ECN/PCN No.: M1101

For Manufacturer		
<b>Product Description:</b> 10/100Base-TX RJ45, Tab Down, LED	<b>Abracon Part Number / Part Series:</b> ARJC02-111006K	<input type="checkbox"/> Series <input checked="" type="checkbox"/> Part Number
<b>Affected Revision:</b> IR	<b>New Revision:</b> A	<b>Application:</b> <input type="checkbox"/> Safety <input checked="" type="checkbox"/> Non-Safety
<p><b>Prior to Change:</b></p> <p><b>Cosmetic Differences</b></p> <p style="margin-left: 40px;">Front (Faceplate) – Front faceplate and LEDs of the original production line.</p> <div style="text-align: center; margin: 20px 0;">  </div> <p style="margin-left: 40px;">Part Marking – Marking appears on the back-side of the device and marked using ink. (part number shown is for illustration only).</p> <div style="text-align: center; margin: 20px 0;">  </div> <p style="margin-left: 40px;">EMI Fingers – fingertips flare outward from body.</p> <div style="text-align: center; margin: 20px 0;">  </div>

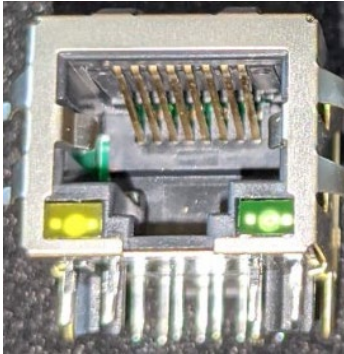
Board Guides – round board guides

Front (Faceplate) – Front faceplate and LEDs of the new production line. LED lenses are slightly more diffused than original production line. This may cause slight variations in luminosity.

Part Marking – Part number will appear on top of device and laser marked (part number shown is for illustration only).

EMI Fingers – fingertips flare inward towards body.

Board Guides – Star board guides
